As-Built Baseline Monitoring Report

Black Gum Creek Wetland Restoration Site DMS Project Number 97063 Robeson County, North Carolina

April 2016

CLARIFICATIONS TO IRT

Figure 2. Asset Map

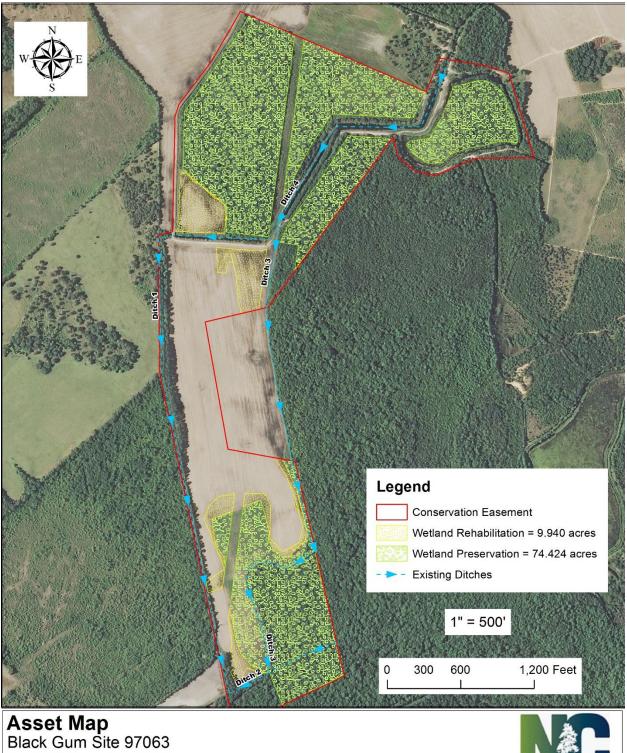
4. DWR does not concur with granting any preservation credit for wetlands that contain ditches. Please check your asset map to make sure that many of the preservation areas do not overlap with ditches on site.

Response: The wetland preservation areas were all deemed jurisdictional by the USACE. A feasibility study conducted by our consultant indicated that "even though these ditches are positively draining the site, the normal flow moving through them is minimal and they are not likely having a significant impact on the local water table. However, they do serve to hold and help drain surface water during storm events."

Figure 3. Current Conditions Plan View

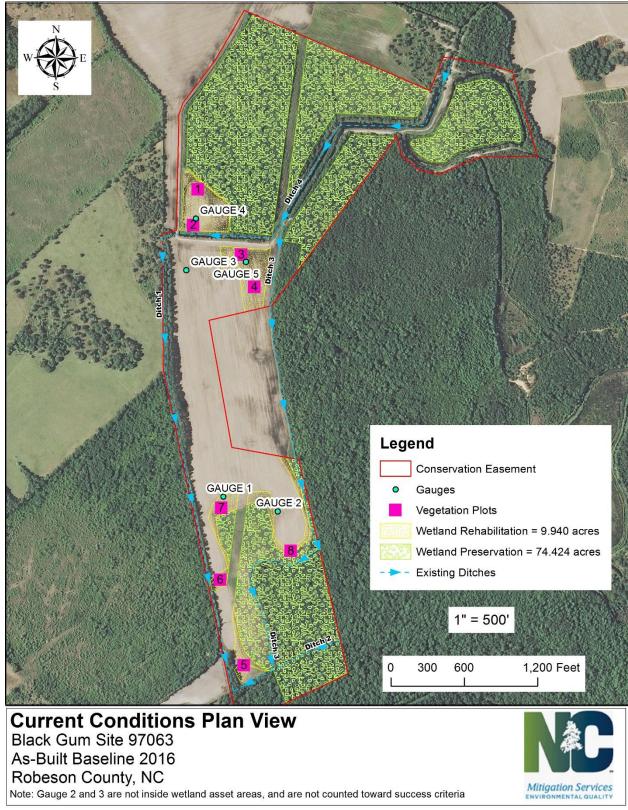
1. The ditch map located in the section with the Jurisdictional Determination should also be placed forward in the document just before the Mitigation Plan View. This is one of the most crucial pieces of information for this project because all the ditches remain open and leads the reader to why this project is primarily preservation and rehabilitation.

5. The northeastern portion of the preservation is open water and should be noted as such on the Mitigation Plan view. DWR believes that this limited habitat is beneficial to the overall site ecology and should be included in the credit.

Response: The map was added as Figure 2.7 – Existing Hydrology Features in the final Mitigation Plan. Ditch locations are also shown on Figure 3 of the Baseline Monitoring Document.

Response: Noted, this area is likely inundated related to beaver activity in the large canal that splits the site. DMS will make note of this area in the Baseline Monitoring Report.
